Subject: Oconee Nuclear Station  
Docket Numbers 50-269, 270, and 287  
Response to Request for Additional Information  
Pertaining to the License Amendment Request (LAR)  
for RPS/ESPS Digital Upgrade  
Technical Specification Change (TSC) Number  
2004-09, Supplement 1

**Attachment 1 – Non Proprietary  
Duke Response to Request for Additional Information (RAI)  
Oconee Nuclear Station License Amendment Request  
for RPS/ESPS Digital Upgrade**

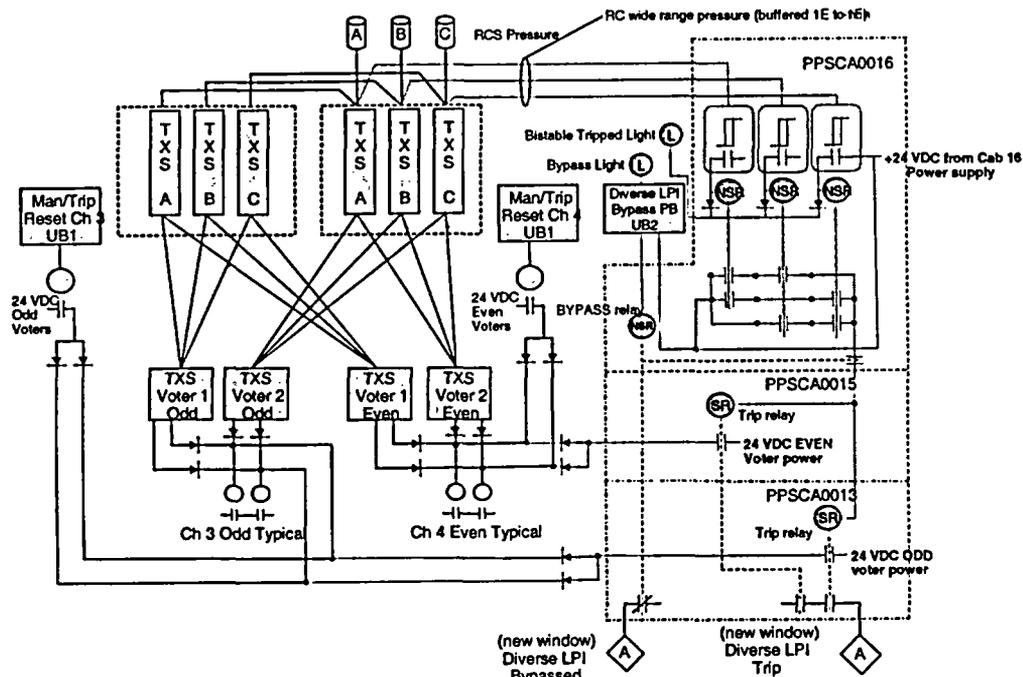
The submittal, in response to plant specific requirement 12, as listed in the NRC staff SER on the TXS Topical Report, stated that a plant specific risk informed Defense-in-Depth and Diversity assessment to justify eliminating the need to install the diverse LPI actuation in early 2005. Please provide that assessment, keeping in mind that NRC has neither reviewed or approved the EPRI report 1002835, "Guideline for Performing Defense-in-Depth and Diversity Assessments for Digital Upgrades."

During the August 17, 2005, RAI meeting, the NRC reviewer requested Duke to provide the design details for the diverse LPI actuation system. Duke provided the design requirements for that system during a November 17, 2004 Duke/NRC meeting. NRC concurred in that meeting as documented in NRC letter dated January 3, 2005 that the

Duke has deferred the submittal date for the risk informed D3 assessment. As indicated in the February 14, 2005, submittal and the April 6, 2005, meeting, the risk informed assessment would be used to eliminate the need to install a diverse LPI actuation system on the two follow on Oconee Units and maintain the diverse LPI actuation systems for the remaining life of the plant. Duke plans to install a diverse LPI actuation system for Oconee Unit 1 in the Fall 2006 outage and will install in the remaining two Units if necessary. Duke will be mindful that the NRC has neither reviewed nor approved the EPRI report 1002835 in any risk informed D3 assessment performed.

The DLPIAS will use analog bi-stable trip units and 2 out of 3 relay logic actuated on Low RCS Pressure. See Figure below.

2. Automatic and manual actuation capability.
  - The DLPIAS will provide for automatic actuation of the Channel 3 and Channel 4 components. This includes LPI pumps, LPSW pumps and LPI Injection valves.

3. Actuate LPI on Low RC Pressure or High Reactor Building Pressure
  - DLPIAS will actuate only on Low Reactor Coolant Pressure. The basis for this is the DLPIAS is intended to provide automatic LPI injection to cover the case of the Large Break Loss of Coolant Accident (LBLOCA) in case the TXS has a common mode software failure. The loss of coolant pressure is the most appropriate indication that a LBLOCA has occurred.
